CARTRIDGE TAPE DRIVES
TABLE OF CONTENTS

CUSTOMER ENGINEERING
SERVICE HANDBOOK

CARTRIDGE TAPE DRIVES

MODELS: 2229
2529
6529

POWER SUPPLY

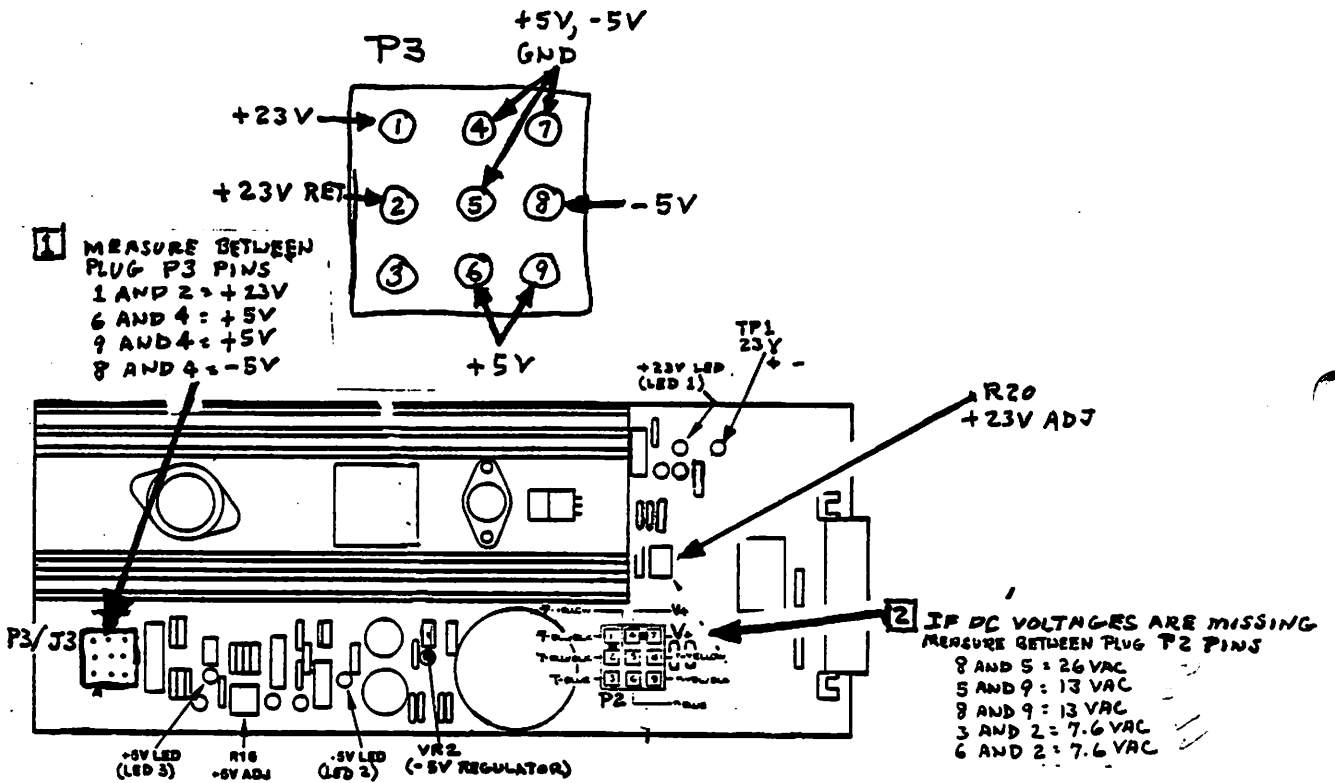
Can measurements be made at P2 + P3?

OIS/V5 ACTD CARTRIDGE TAPE PCB VOLTAGE MEASUREMENT

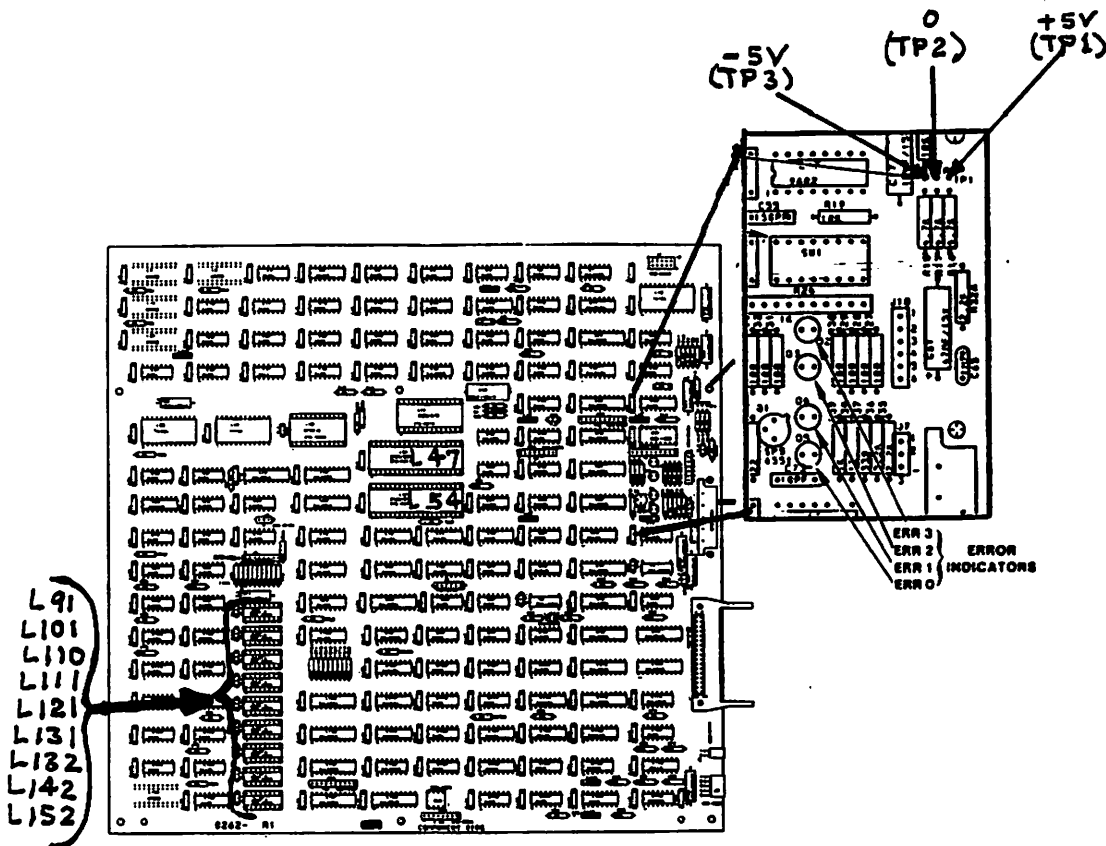
Is TP2 common point for volts measure?

INTERLOCK SWITCHES

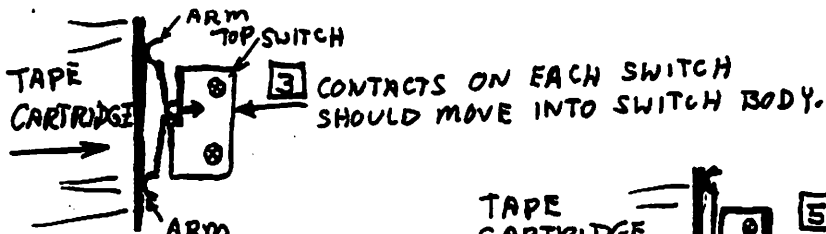
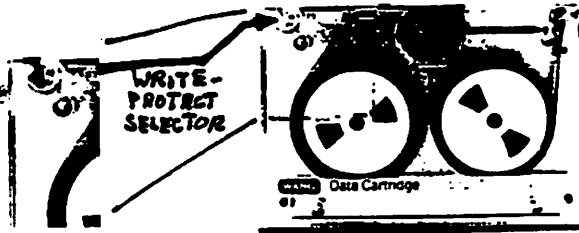
Procedure ok??

READ LEVEL ADJUSTMENT

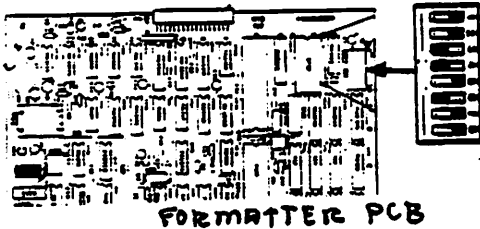
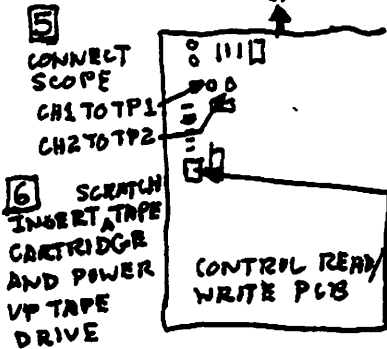
Does it make sense to do steps 1 + 2? A info correct?
How high volts & how much adjust. is permitted in step 8??

Rework

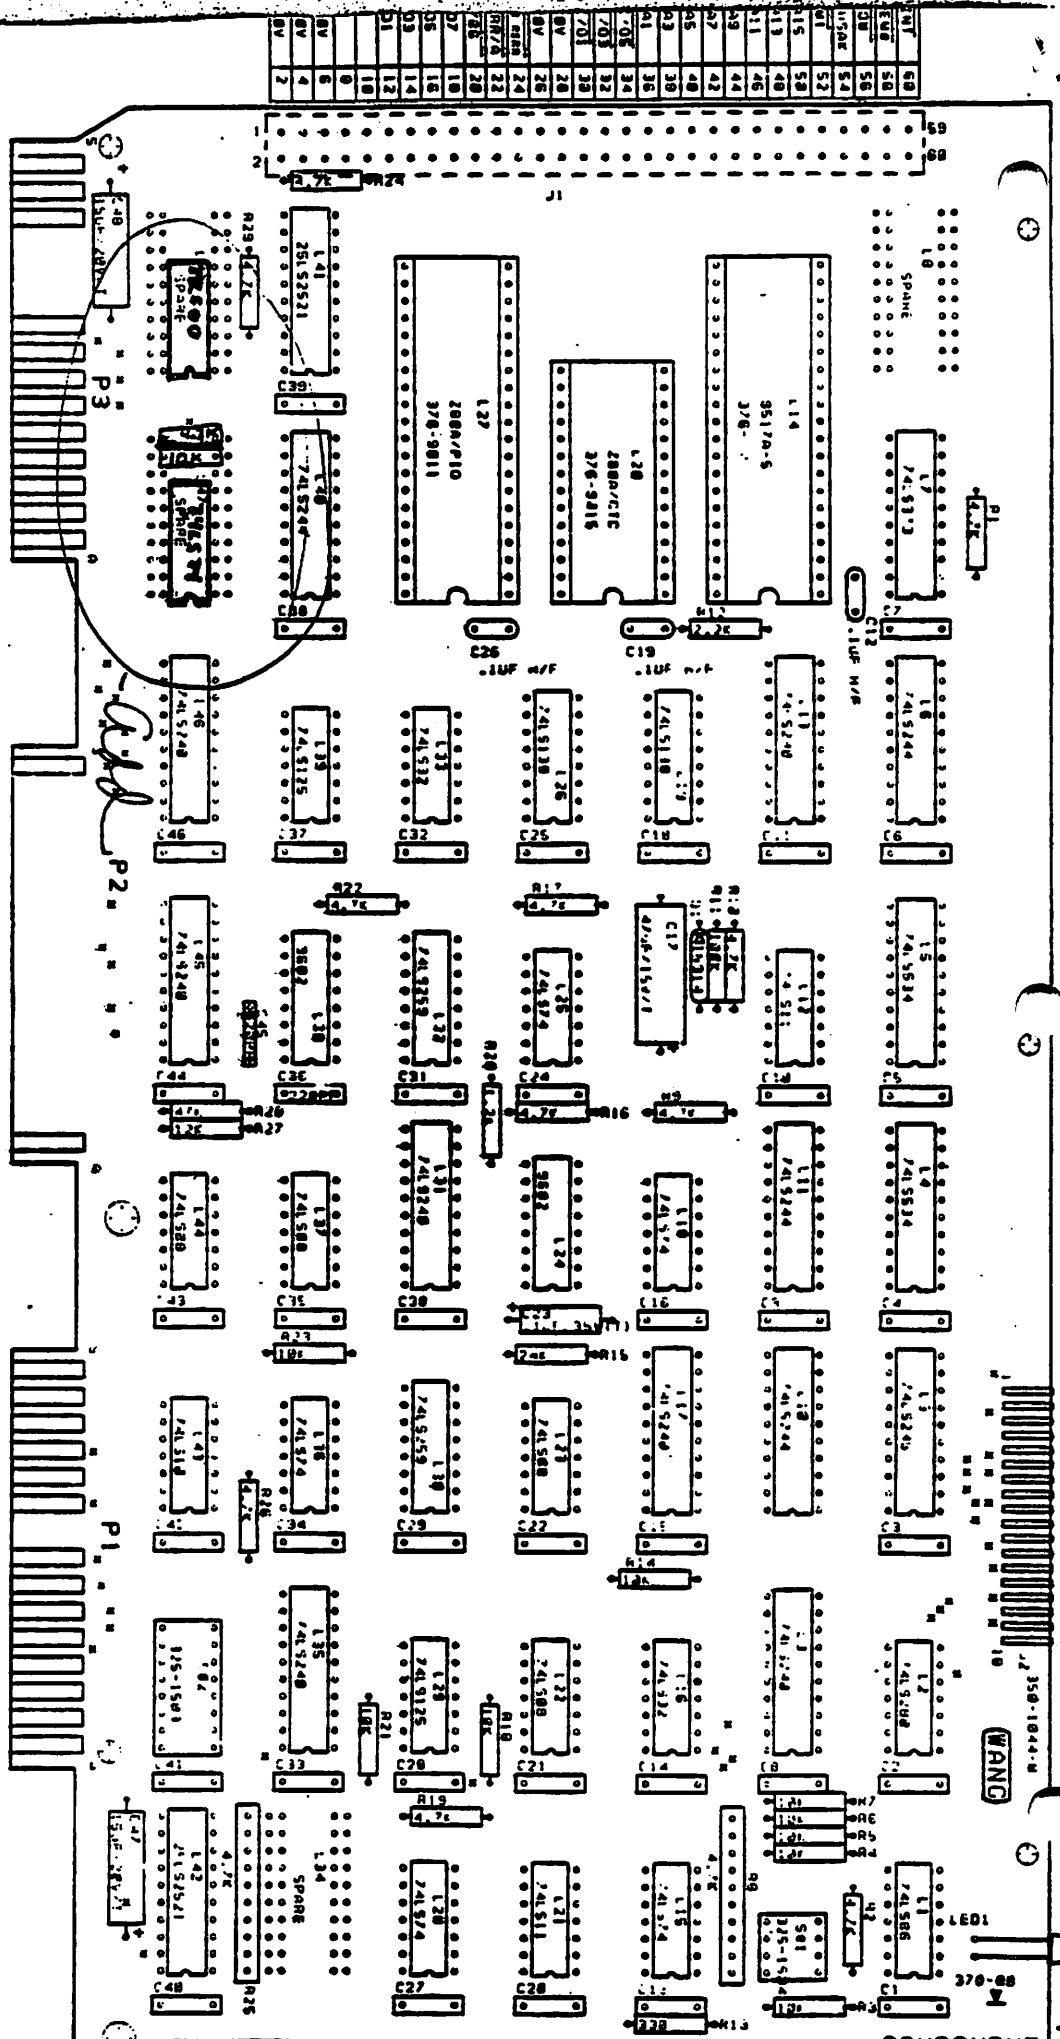
1. Cut run from L-14 pin 4 to feed through. (component side) (7me1f3)
2. Cut and lift L-12 pin 2. (7me163)
3. Cut and lift L-12 pin 3. (7me1f3)
4. Cut and lift L-44 pin 10. (7me163)

5. Install 74LS74 (376-0155) at L-47. (7me163)
6. Install 74LS00 (376-0207) at L-48. (7me163)
7. Install 10k resistor (330-4011) at L-47. (7me1D3)
8. Install 4.7k resistor (330-3048) at L-47. (7me1D3)

9. Replace L-14 9517A-5PC (377-0435) with 9517A-4PC (377-0411).
10. Jumper L-46 pin 10 to L-47 pin 7 to L-48 pin 7.
11. Jumper L-46 pin 20 to L-47 pin 14 to 10k resistor to 4.7k resistor to L-48 pin 14.

FIGURE 1: TAPE DRIVE, SIDE VIEW
WIRE AND LUG ASSEMBLY INSTALLATION

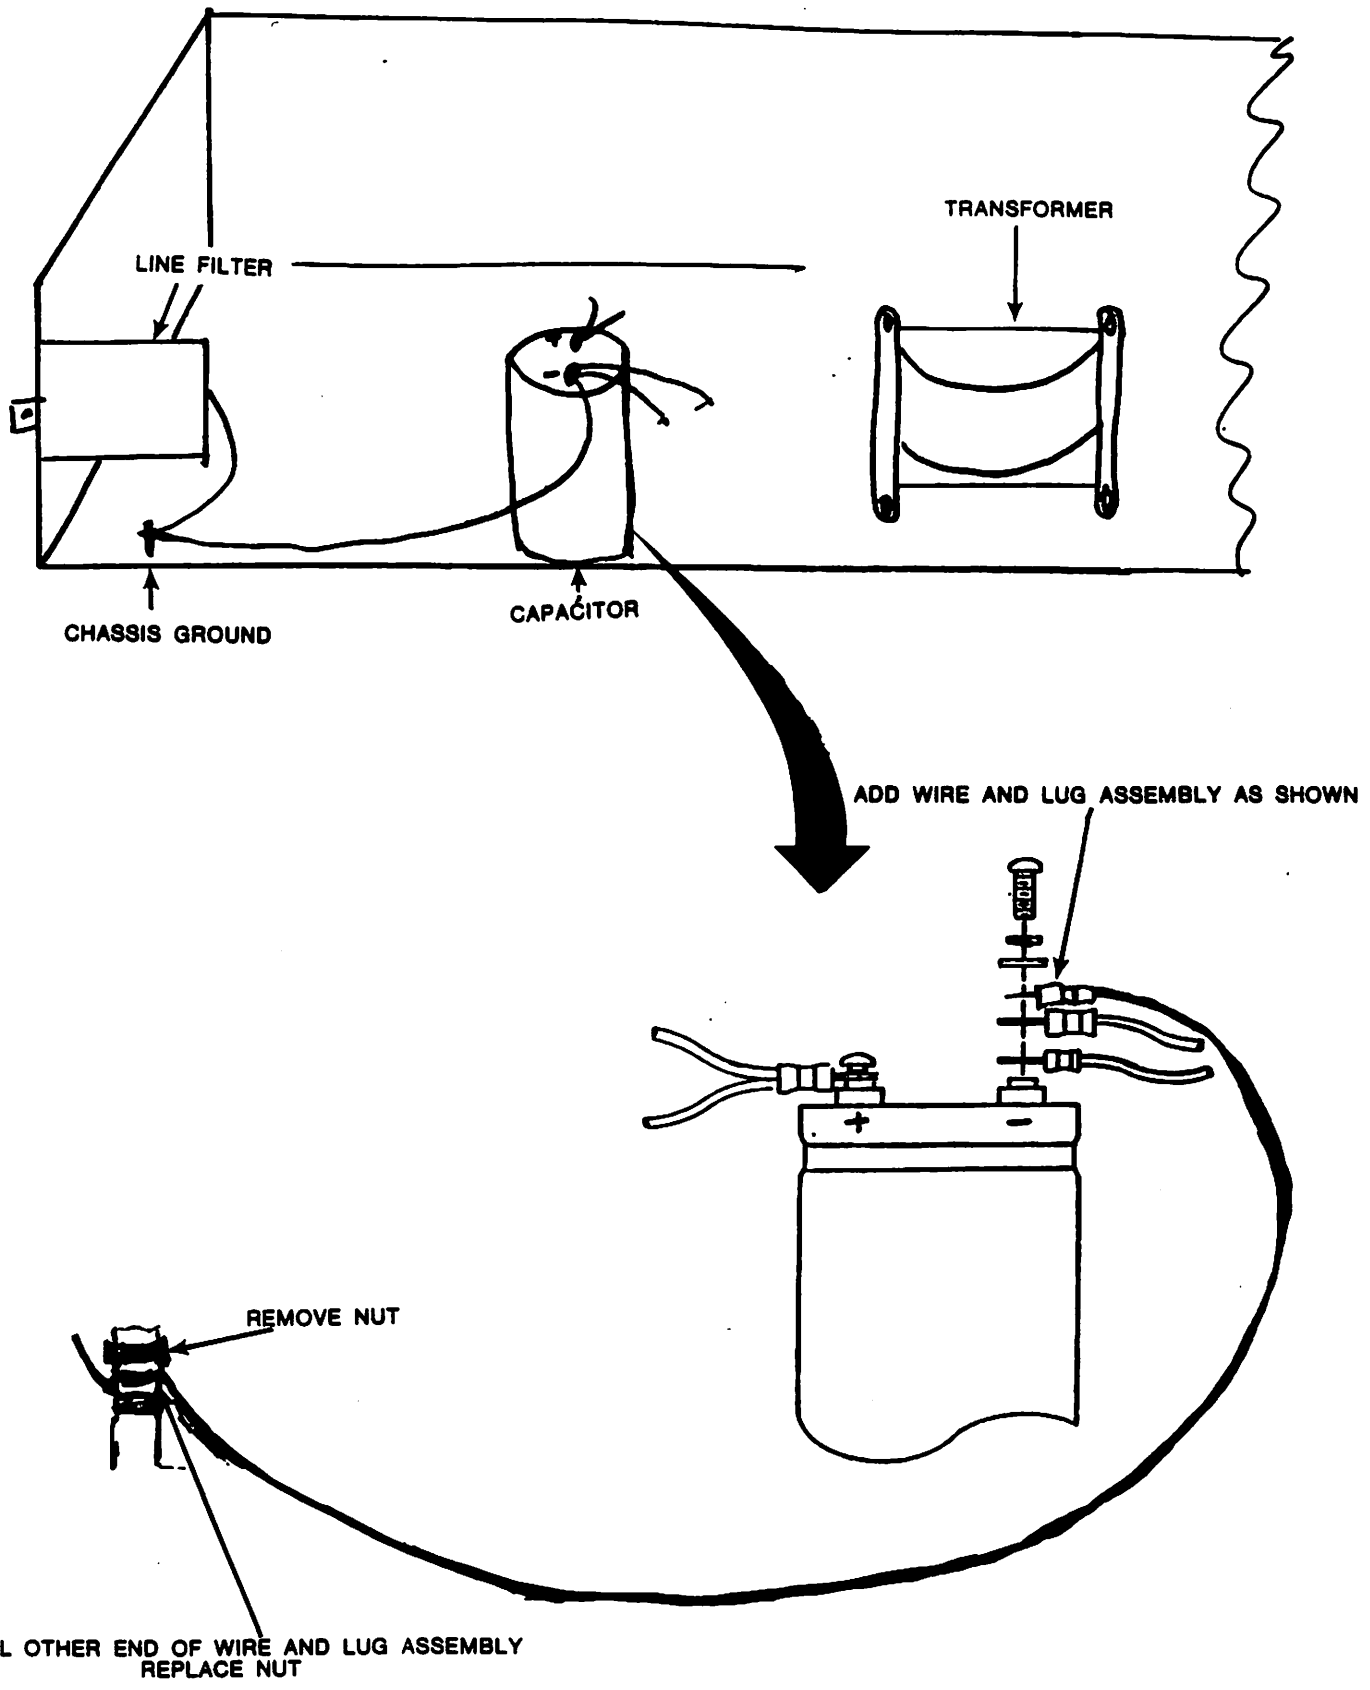
A wire and lug assembly is added between the capacitor in the power supply and chassis ground.

- C. Add the wire and lug assembly between the capacitor and chassis ground as follows: (Figure 1)
1. Remove the screw on the negative post of the cap. (The negative post is not marked, but it has black wires and a blue wire with a black stripe attached.)
 2. Add one end of the wire and lug assembly. Insert the screw through the two washers and three lugs and thread the screw back into the cap.
 3. Remove the nut from the chassis ground screw located under the line filter at the back of the unit. Place the other end of the wire and lug assembly over the screw and replace the nut.
- D. Replace the cover of the unit by reversing the procedure described in step B.
- E. Perform check-out procedure described in Section 6.
- F. Document installation of this FCO by completing a Call Report or Activity Report.

ILLUSTRATION A

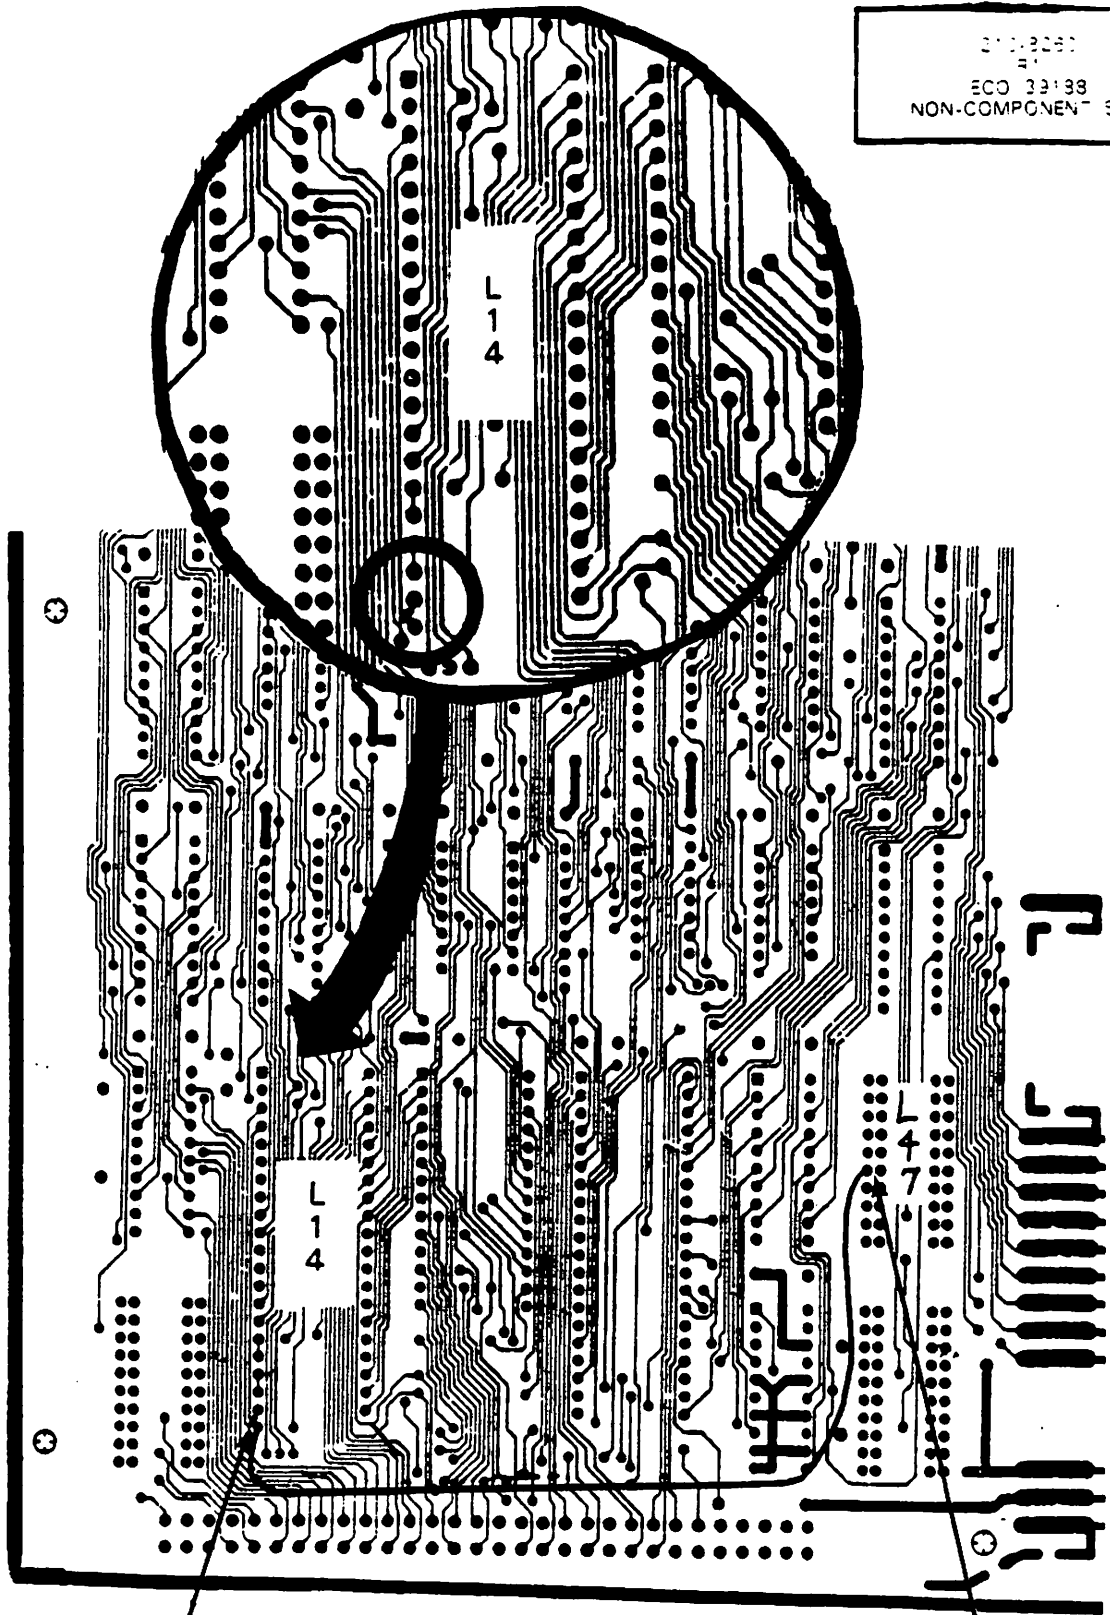
CUT ETCH OF L14-4 ABOVE
PLATETHRU LOCATED BELOW
L14-20, AS SHOWN

210-8260
R1
ECO 39188

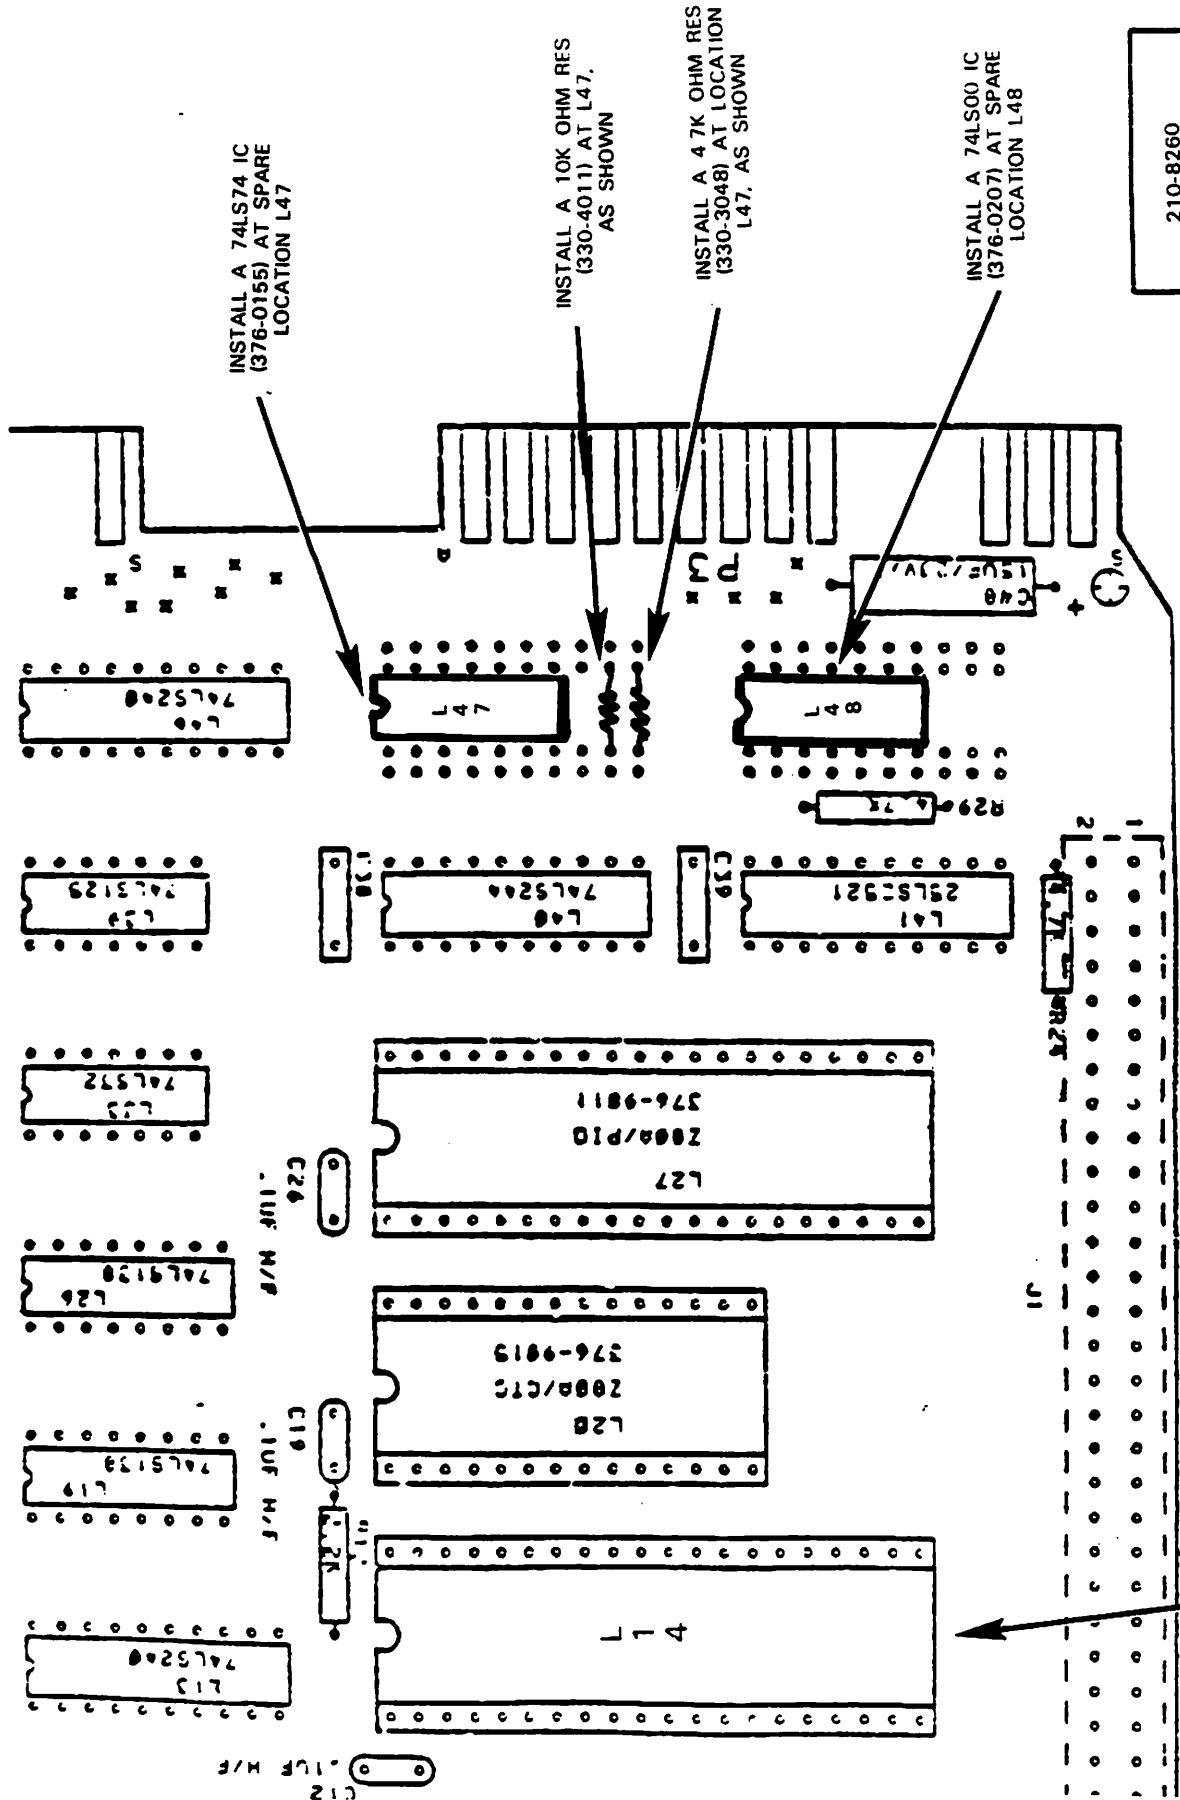
JUMPER FROM L47-6 TO
PLATETHRU BELOW L14-20,
AS SHOWN

CHANGE L14 TO A
(377-0411) IC
